# Technical Service Information

## THM 3T40 (125C) SLIPS IN FIRST GEAR

Figure 1

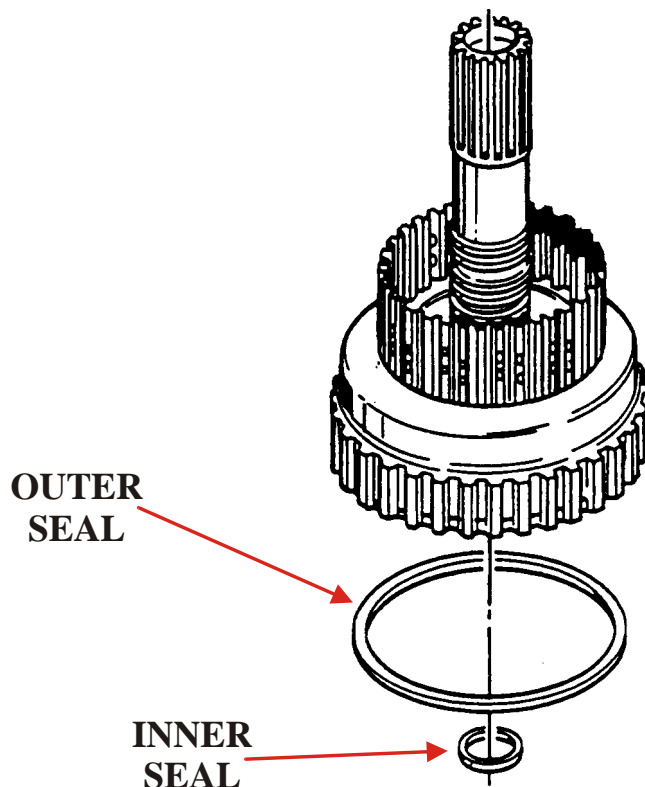
**COMPLAINT:** Slips and/or chatters when taking off in 1st gear. In extreme cases, no forward movement until vehicle is warm.

**CAUSE:** The cause may be forward clutch lip seals which may become brittle and take a permanent heat set after high mileage allowing leaks to occur in the forward clutch.

**CORRECTION:** There are now available new Forward Clutch Piston Lip Seals made of "Viton", which replace the currently used lip seals. The new "Viton" lip seals are available under OEM service package 8631986. Use this part number until the new seals are included in gasket packages.
